. CITY OF SACRAMENTO .
. DESIGN REVIEW - PRESERVATION BOARD .

PROPOSAL: The applicant proposes construction of a Price/Costco retail store.

DR95-218

SITE PLAN

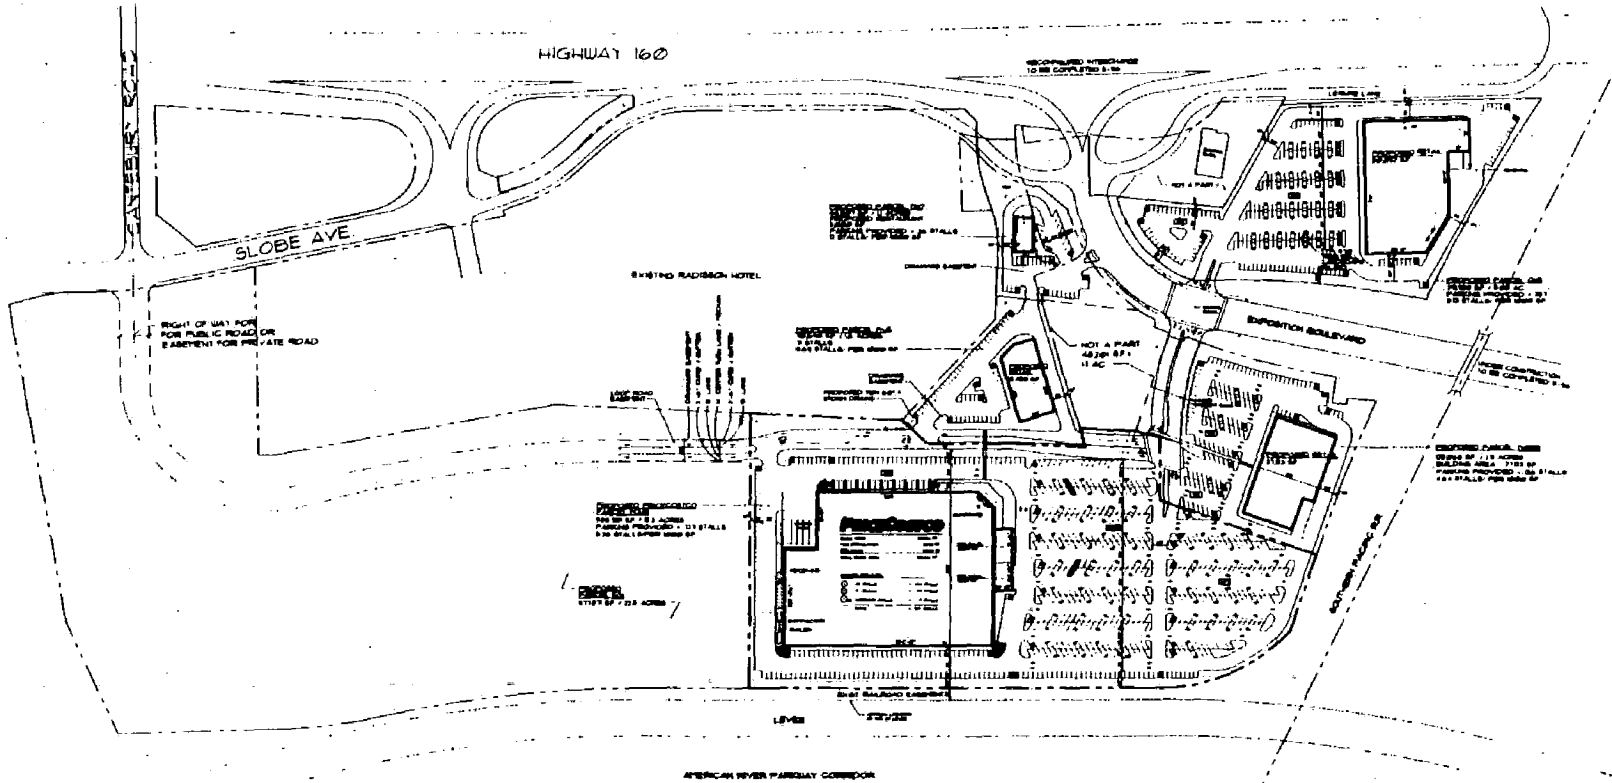
1. The applicant has indicated that some studies have been done to determine the best location for the building on the site. The American River Parkway Corridor has maximum heights and distances from the levee wherein a building may be placed. See attached excerpts from Section 24 of the Zoning Ordinance.

2. The applicant currently intends to provide more parking than is required by the City. Landscaped areas should be maximized on the site. The North Sacramento Commercial, Office, and Industrial Design Guidelines encourage applicants to exceed, where possible, the minimum shading requirements of the City Ordinance.

3. The parking layout may need additional enhancement to allow more pedestrian friendly transition from parking areas to the store entries. Tree lined walkways or special paving are some ways to better delineate the pedestrian walkways. The North Sacramento Design Guidelines encourage accent paving at entries to parking areas coinciding with enhanced paving at building entries.

4. The south property line that borders the levee should be enhanced with additional trees native to the riparian and flood plain areas to provide a visual buffer between the levee area and the site. This landscaped area is currently indicated on the plans to be 20'-0" wide.

12. The North Sacramento Design Guidelines state that service access, including loading docks, should not obstruct the flow of pedestrians or user circulation, or not to create an unsightly condition. The Guidelines also state that loading docks and service doors should be located out of view from primary street frontage and entry.
